Passing orders on letter from
the S & of Police subuf for the approval
of joint a standard plan & estimate
for the construction of Head Quarters
Police Hospitals.

Submitting for the
Approval of His Excellency
the Governor in Council
Standard plan and Eotin
for the construction of a
Head Quarters Police Hospital

I have the honour to state that, with reference to para 10 of the Surgeon-General's letter to Government No. 172/Tour, dated 6th June 1896, embodied in G.O. No. 800, Public, dated 3rd August 1896, the Sanitary Engineer to Government has prepared a standard plan and estimate for the construction of a Head Quarter Police hospital.

2. The following is the rough sketch of the proposed site plan and buildings for a Head Quarter Police Hospital.

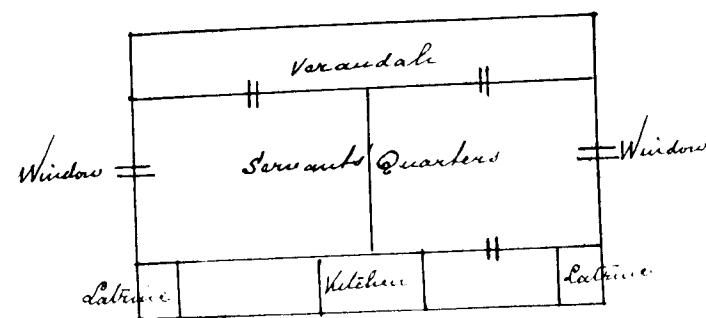
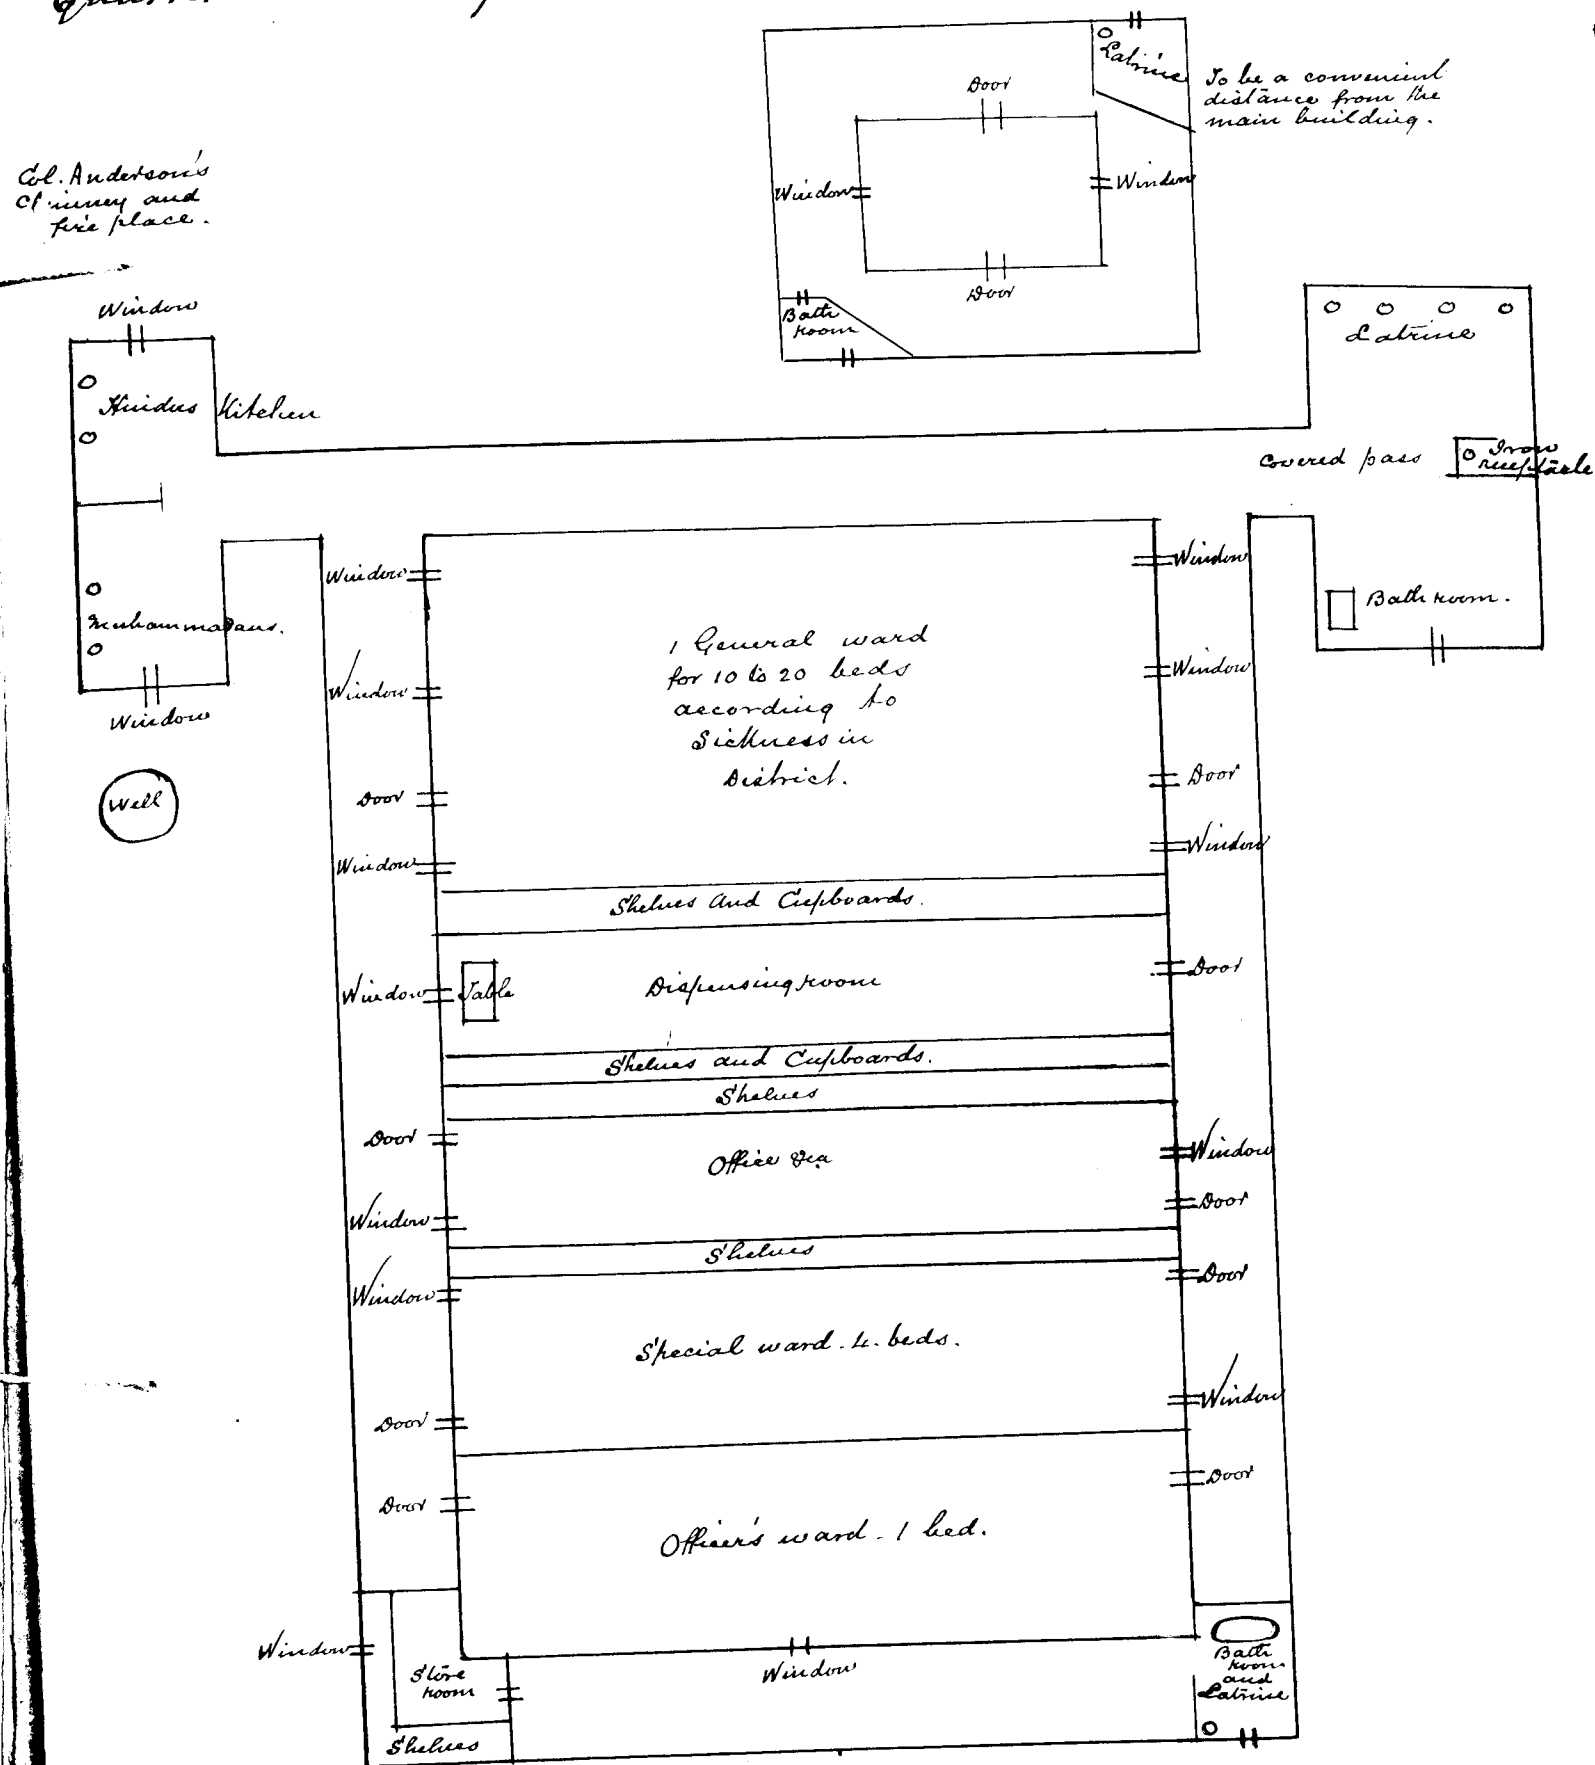
see that we require more than this. I consider your sketch plan, although it is no doubt excellent, indicates a building beyond our needs and one which it is useless to ask Government to allow us to build at the present time. We must cut down the expenditure of these buildings to the lowest possible limit.

2. I concur with you for the reasons you gave that the ward for officers is not required nor will the special bath room and latrine in the corner be required.

It is desirable that the dispensary or compounding room should be separate from the office. These two rooms and the store room will alone have permanent walls, the walls of the wards being of mat in frames will diminish the cost considerably.

3. I also concur with you that an isolation ward, as proposed, should alone be sanctioned where the accommodation in the nearest Civil or Municipal Hospital is insufficient, but I consider that, as a rule, it will be better to have such a ward for the sick of the police in connection with their own hospital.

4. The huts for the hospital servants I consider most

5. The store room in the corner is very necessary and will cost but little. If no such room exists, it means that there is no place to lock up furniture, bedding and clothing, empty boxes &c., which are not in use.
